REQUEST

Current Zoning: N1-A (single family residential)
Proposed Zoning: R-8MF(CD) (multi-family residential, conditional)

Approximately 42.46 acres located along the north side of Rocky River Road, west of Back Creek Road, and southeast of John Russell Road.

SUMMARY OF PETITION

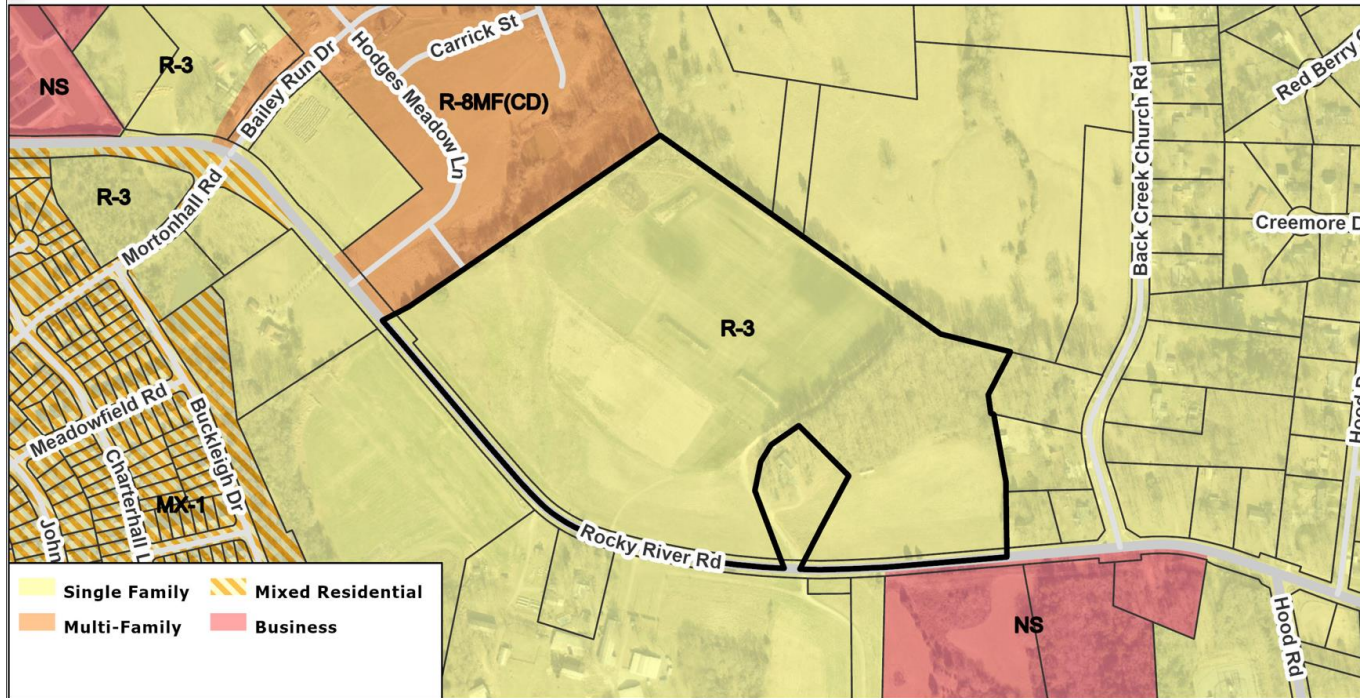
• Proposed Request Details

The site plan accompanying this petition contains the following provisions:

- Allow up to 200 single family attached (triplex and quadraplex) residential units and/or townhomes.
- Proposes the following transportation improvements:

- Proposes access from Rocky River Road and Future Eastern Circumferential Road.
 - Commits to an eight-foot-wide planting strip and 12-foot wide multi-use path along Rocky River Road.

- Construct bicycle facilities by locating the curb and gutter 30 feet from the Rocky River Road center line and installing the 12-foot multi-use path.

- Commits to construction of a four-foot median on Rocky River Road.
 - Proposes an internal network of public streets with six-foot sidewalks and eight-foot planting strips.

- Constructs Public Street B as a right-in/right-out access point and widen Rocky River Road to install a dedicated right turn lane into the site with 100 feet of storage in coordination with NCDOT.

- Widens Rocky River Road to construct a dedicated left turn lane with 150 feet of storage and right turn lane with 100 feet of storage at Public Street C in coordination with NCDOT.

- Proposes the following architectural standards:
 - Proposes a combination of the following building materials: brick, natural stone, stucco, cementitious siding, fiber cement and/or other approved materials.

- Prohibits vinyl siding, excluding vinyl handrails, windows, soffits, doors or door trim; and concrete masonry units not architecturally finished.
 - Limits the number of units per building to a maximum of four (4).

- Limit maximum blank wall expanse to 20 feet on all building levels fronting network-required streets.
 - Provides a four-foot minimum berm along Rocky River Road.

- Provides minimum 0.25 acres of improved open space areas with amenities includes at least one of the following enhancements: hardscape features, seating areas, benches, trail network and/or enhanced landscaping.

- Dedicates and conveys a minimum 1.5 acres to Mecklenburg County Park and Recreation for the purpose of a public future neighborhood park.
 - Illustrates a 30-foot Class C buffer adjacent existing multi-family residential and a 50-foot Class C buffer adjacent single family residential.

- Illustrates possible tree save area and internal walking trail.
- Petitioner shall contribute \$7,500 to CATS for bus stop improvements to include a shelter with seating at the intersection of Rocky River Road and Grier Road. Contribution shall occur prior to the issuance of the first building certificate of occupancy.

- Petitioner shall contribute \$5,000 to the Far East Neighborhood Coalition. Contribution shall occur prior to the issuance of the first building certificate of occupancy for the site.
